From: [REDACTED]
Sent: 31/08/2023 11:41:48 AM
To: Council Northernbeaches Mailbox
Cc: 'John Fortescue'
Subject: TRIMMED: Submission (objection) DA2022/1164 FAO Mr Alex Keller
Attachments: Building Submission DA2022_1164.docx; Objection to development at 34-35 South Steyne Manly.pdf;

Building Submission DA2022/1164 34-35 South Steyne Manly

OBJECTION REPORT

DA2022/1164

Appendix 2 - Views

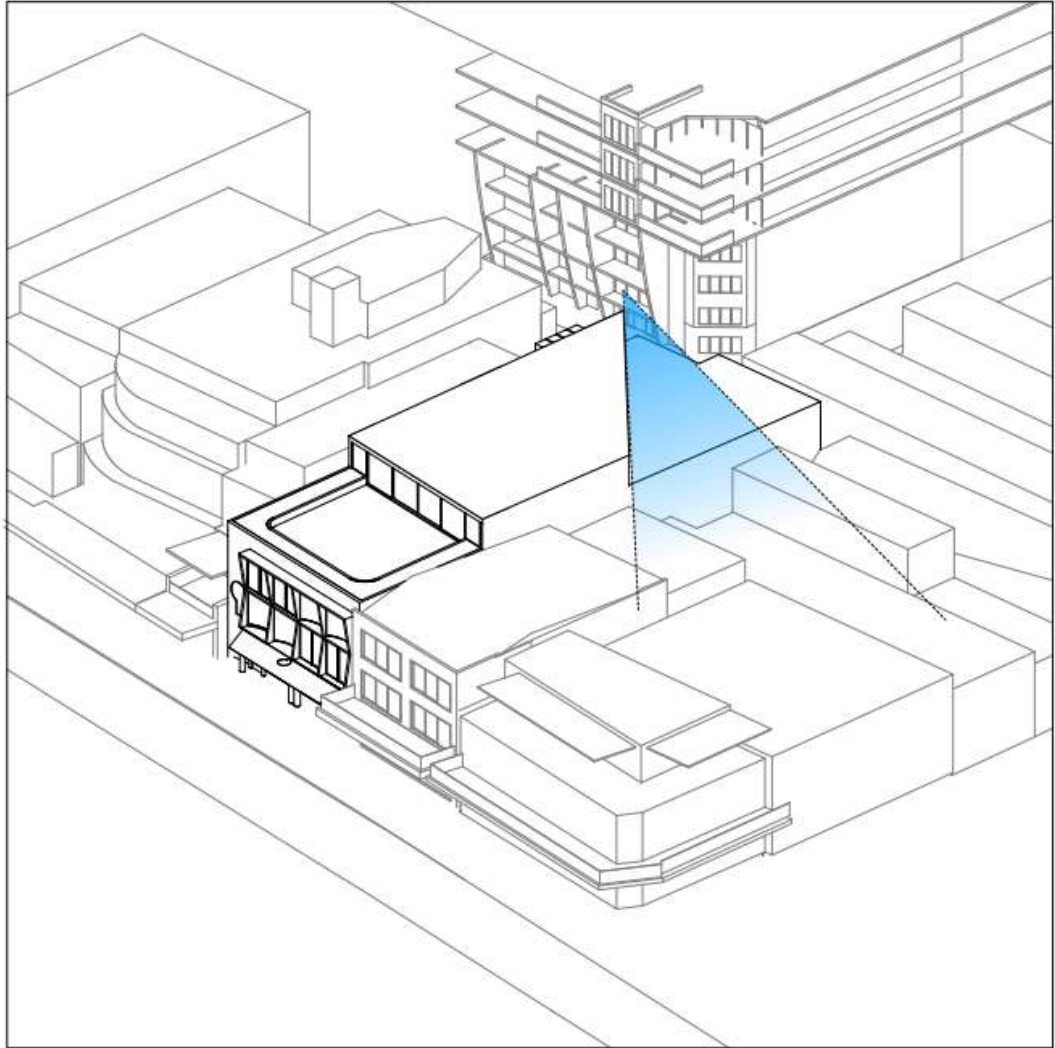
This depicts a false narrative of the view impact to my flat – the apex of the blue shaded area.

Note if building is developed to plans, we loose sight of beach on right side of picture. On the description they say we don't loose views.

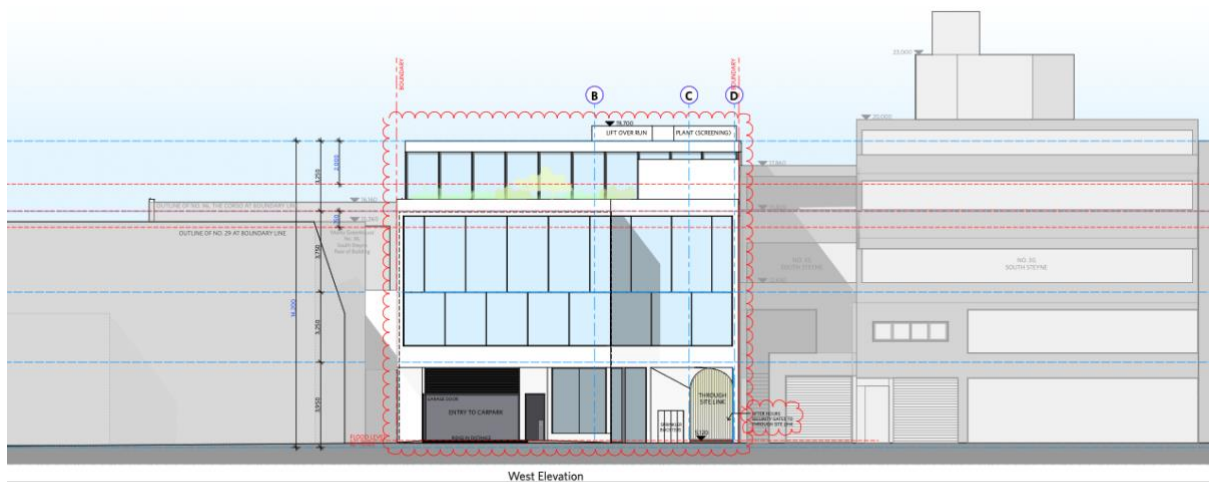
Comment: The screenshot of the east elevation below shows that the development is not consistent with the height of buildings to the north of the site with the fourth floor presenting as a substantial addition compared to the height of these buildings. The development to the south was approved under the previous Local Environmental Plan and, at the time, was a controversial approval resulting in substantial view impacts on adjoining residences and was subject to an Ombudsman review. It is therefore not appropriate to use the southern building as an example of an established building height for the streetscape. It is not considered that the proposed development complies with this objective as provided above
